2007 Mercedes Benz Truck ML 350 4MATIC (164.186) V6-3.5L (272.967)

No cooling output, fault code 9006 in air conditioning control unit

Topic number	L183.30-P-049644
Version	7
Design group	83.30 Air conditioning
Date	11-15-2016
Validity	All veh. of model series 164/251
Reason for change	Damage code adjusted

Attachments	
File	Description
Massepunkt W16-4.jpg	Ground point W16/4

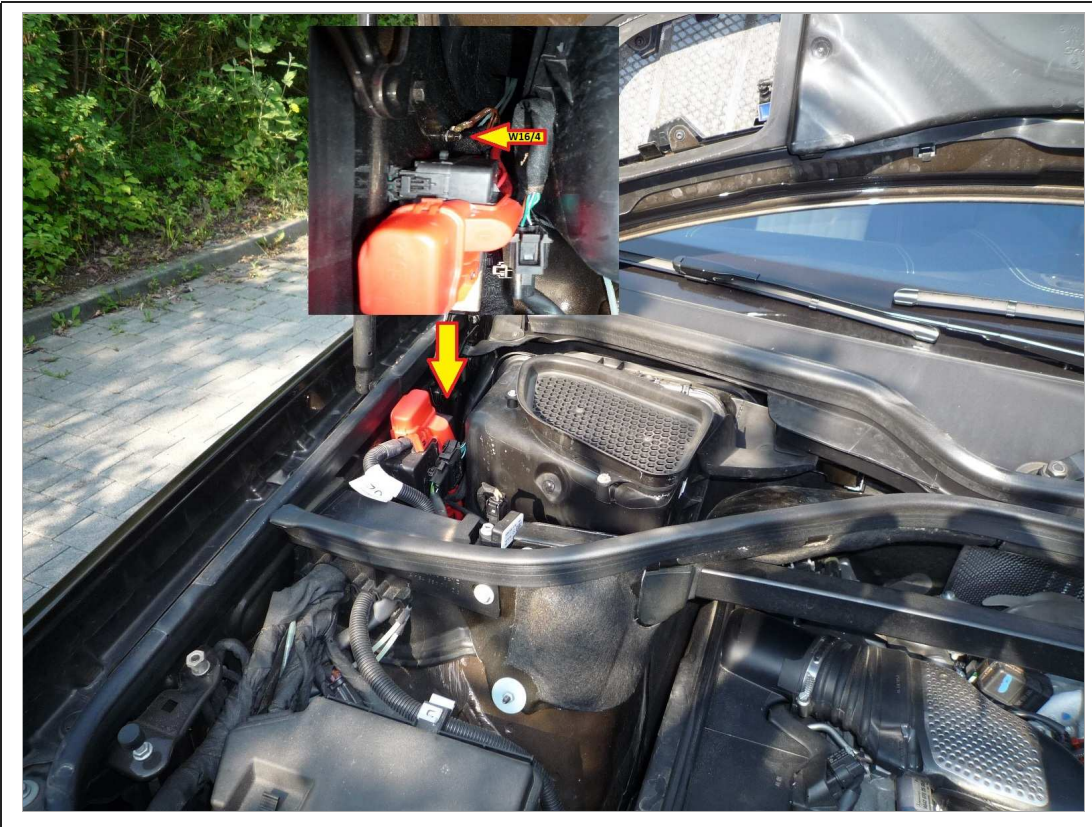
7. From the connection of the regulation valve on the refrigerant compressor one cable with a cable lug is bolted onto the housing of the refrigerant compressor as a ground line; the other cable goes via the connector to the engine wiring harness. An additional ground line with a cross section of 0.75 mm² must be properly routed from the bolt-on point of the ground cable on the housing of the refrigerant compressor to ground point W16/4 in the front right of the engine compartment below the engine hood hinge (see photos in attachment).
